**NORTHSTOWE PHASE 1**

NON-MATERIAL AMENDMENTS TO APPROVED PLANS

PLANNING STATEMENT

GALLAGHER LONGSTANTON LTD

**Gallagher**  
**Northstowe**  
Plan 2  
Parameters plan  
Movement and access

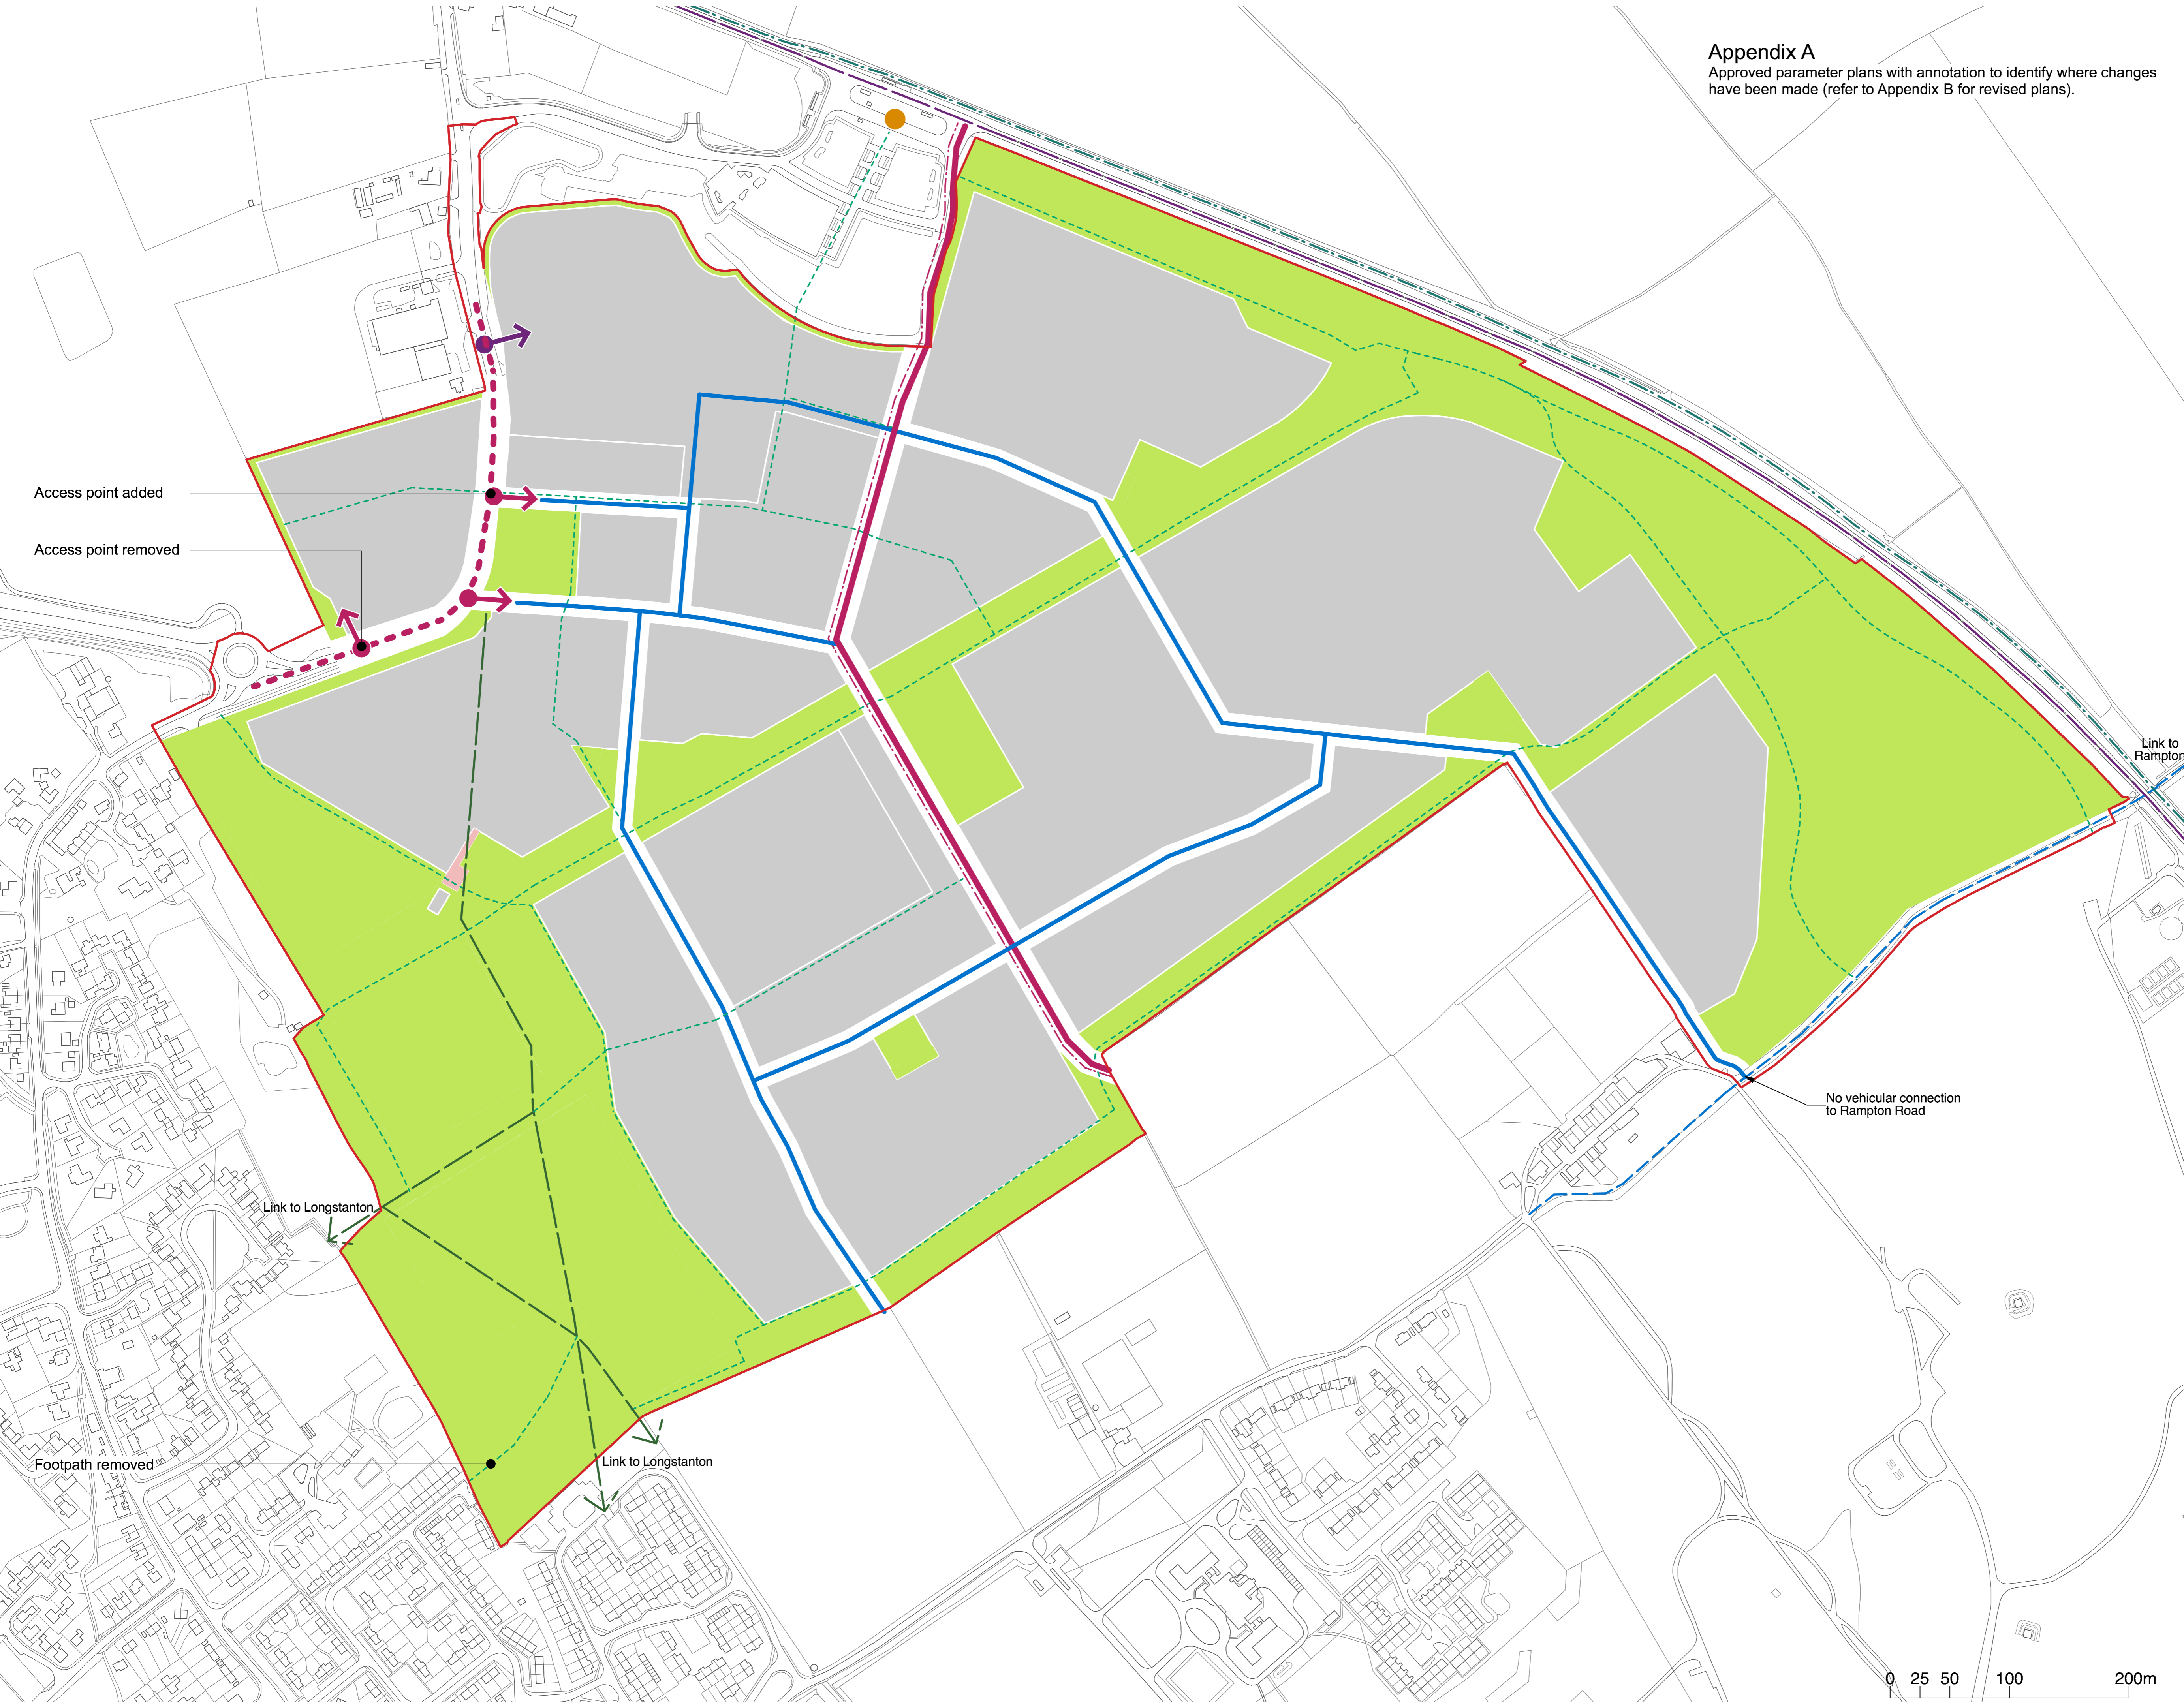
Access point added

Access point removed

Footpath removed

No vehicular connection to Rampton Road

- 2.17 The revisions to parameters plan 2 (movement and access), which involve the removal of the southernmost access into the residential parcel on the western side of the B1050 and its replacement with an access opposite the local centre, to form a crossroads reflect those discussions and in particular the scheme presented to and discussed at the Northstowe Transport Working Group (NTWG) meetings on 13<sup>th</sup> March and 17<sup>th</sup> July 2013. As noted under section 6 of the minutes of the NTWG meeting on 17<sup>th</sup> July (refer to appendix C) the group had no negative comments on the proposals.

- 2.22 A footpath was shown in the south west corner of the site on parameter plan 2 (movement and access). As a result of more detailed design work as part of the design coding process and further consideration of tree constraints in this part of the site, it is no longer proposed to provide this footpath. Connections to Longstanton will continue to be achieved via the existing public rights of way that access the site from Magdalene Close to the east and Prentice Close to the north, as shown on parameters plan 2 (refer to appendix B).
